PERMIT NO. **RM#24-00028**

W Architect Inc.
DESIGN CONTROL REVIEW

CITY OF RICHMOND HILL
BUILDING DIVISION
08/21/2024
REVISED
Per: KER

project name
Trinigroup Developments Inc.

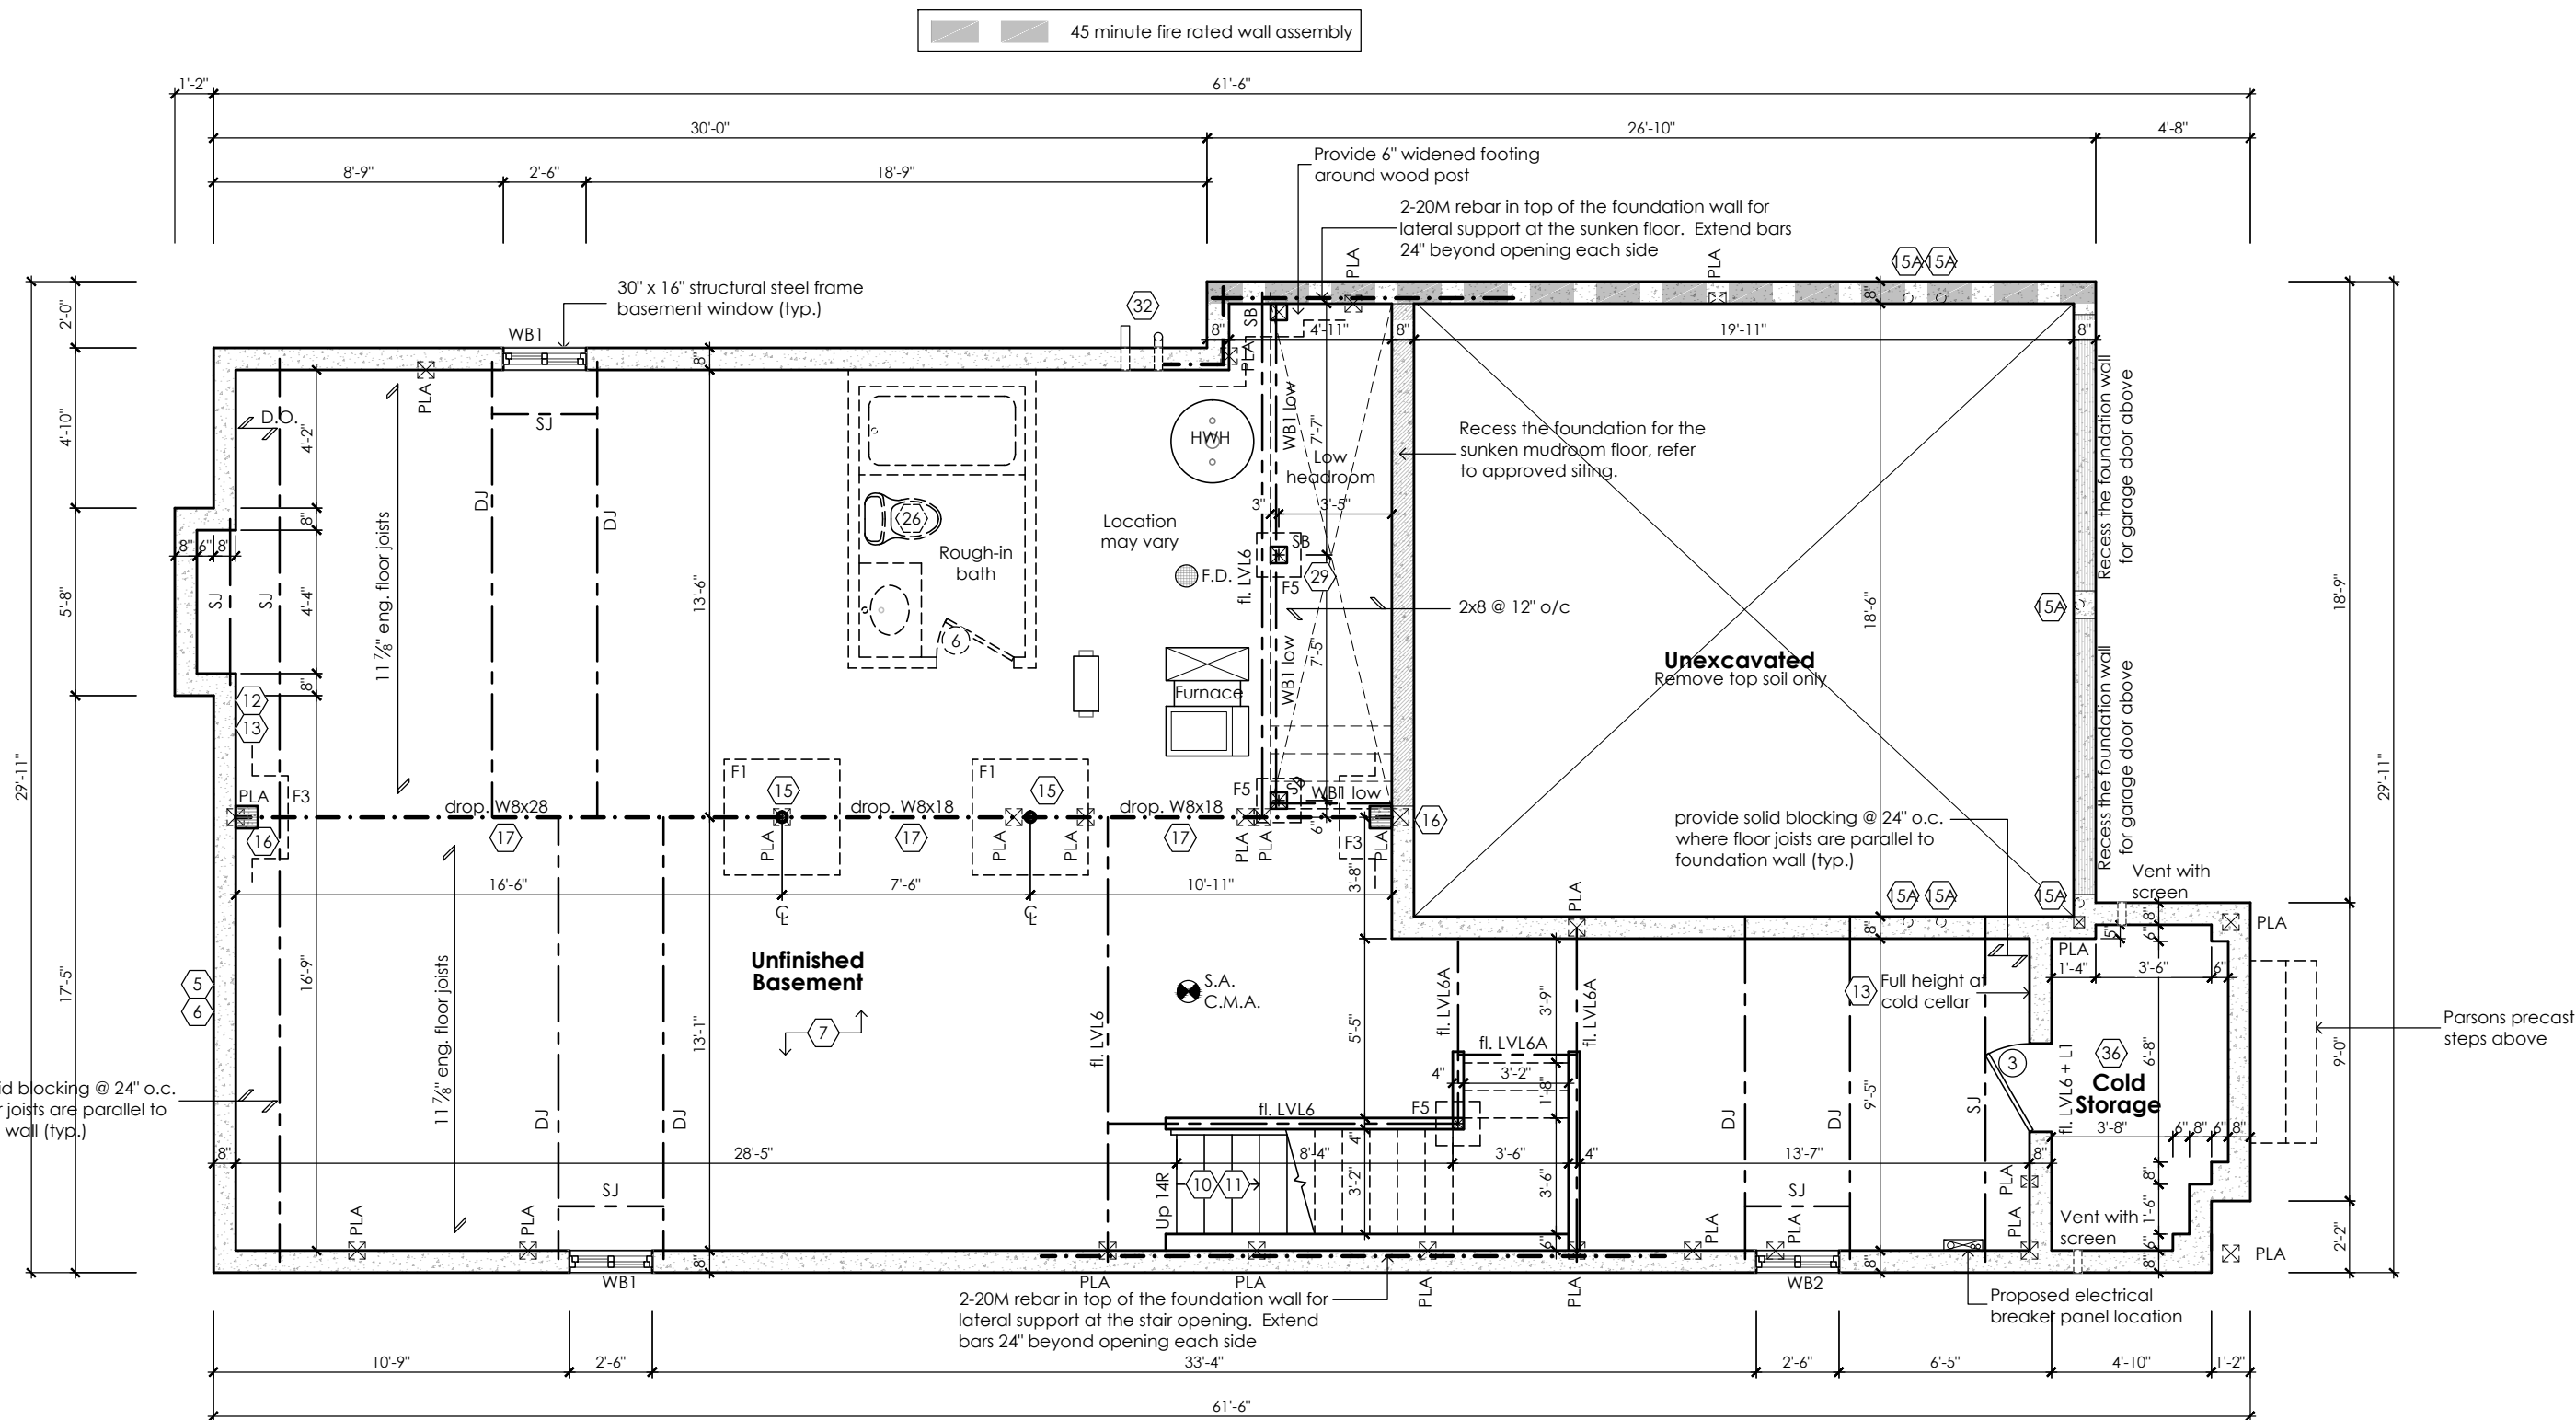
Assumed 120 kPa (18 psi) soil bearing capacity or 90 kPa engineered soil fill. Bearing capacity to be verified on site, **by soil engineer report**

F1 = 42" x 42" x **2'8"**

F2 = 36" x 36" x **1'8"**

F3 = 30" x 30" x **1'8"**

F1 = 48" x 48" x **2'8"**

F2 = 40" x 40" x **2'8"**

F3 = 34" x 34" x **1'4"**

F4 = 28" x 28" x **1'4"**
